2022 Oregon Structural Specialty Code Issued Errata

The following is errata for the published 2022 Oregon Structural Specialty Code (OSSC), which is based on the 2021 International Building Code (IBC).

FIGURE 1613.2.1(1)

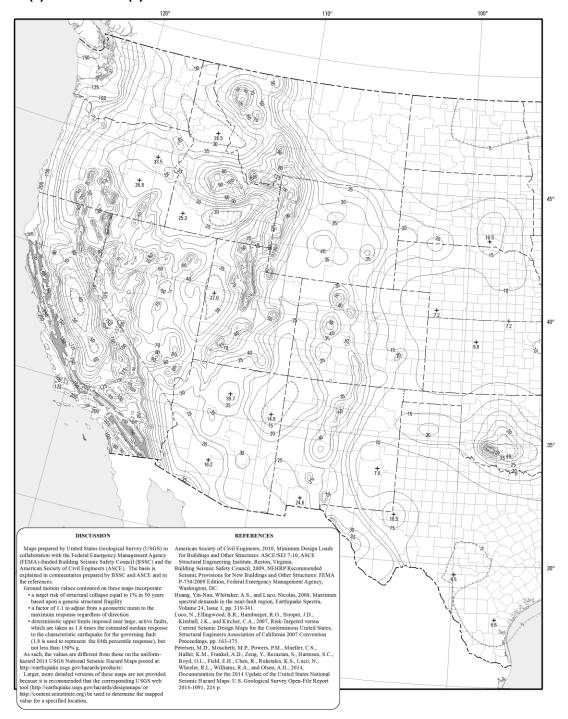
Figures 1613.2.1(1) and 1613.2.1(2)
